Exchange No. 79612

APPLICATION FOR EXCHANGE OF WATER

CHANGE P.O.D. 61-349, 61-353, 61-356, 61-357

Re: Water Right Exchanges (#79609, 79610, 79611, 79612), Additional Information Request

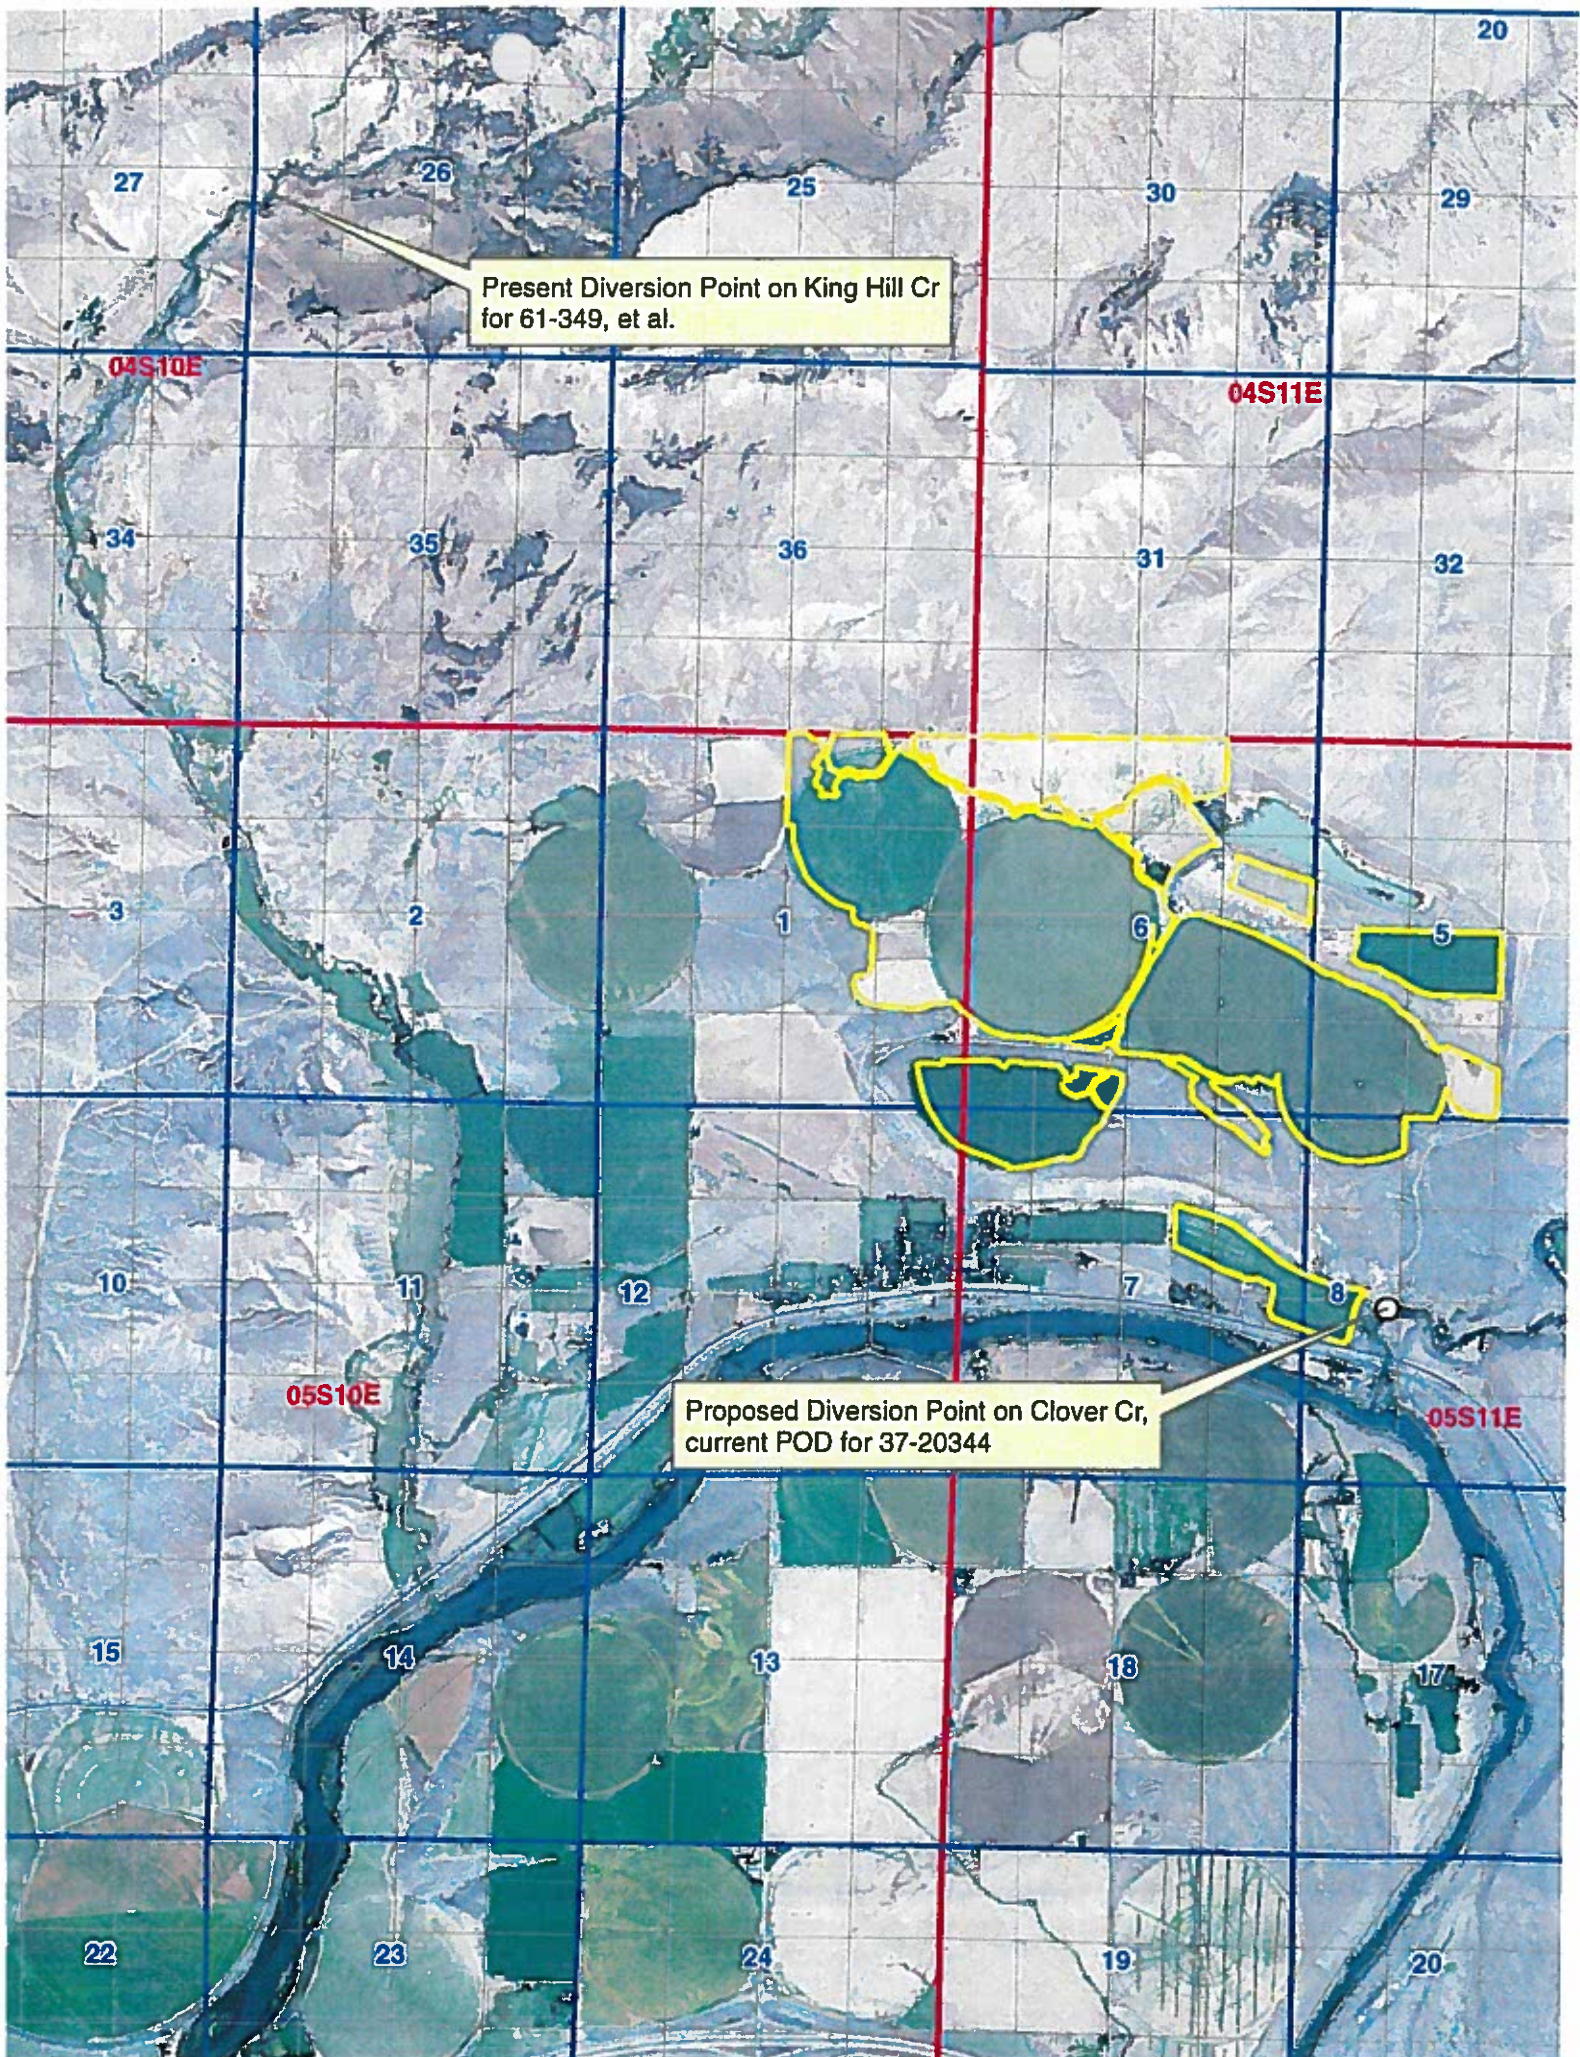
Pitchfork Ranch has proposed exchanges for 4 water rights diverted from King Hill Cr (rts 61-349, etc). The proposal is to then divert the rights from Clover Cr in Basin 37 at a point that already exists. The attached map portrays the circumstances.

There are some junior rights downstream from the present Pitchfork Ranch diversions. King Hill Cr has historically been a watermaster district, 61F, do either one of you know if it is active and, if so, then who would I be in touch with?

Corbin, as Basin 02 water Master, do you perceive of potential injury and/or recommend conditions? It would appear that a condition would be needed to limit diversion from Clover Cr to those priorities and flow rates that water is available from King Hill Cr. However, if there is no watermaster then how could it be regulated? Would Pitchfork need to measure water discharged to the Snake River from King Hill Cr (or at least measure below the junior downstream diversion) and limit exchange to that rate of flow? Do we have a capability to have Pitchfork self report flow rates and diversions? If the proposal is not administrable, then can/should we approve it?

If we are going to approve it then Southern Region is contemplating making the rights subordinate to all rights in Clover Cr. However, there isn't a watermaster on Clover Cr so we are back to the regulatory question.
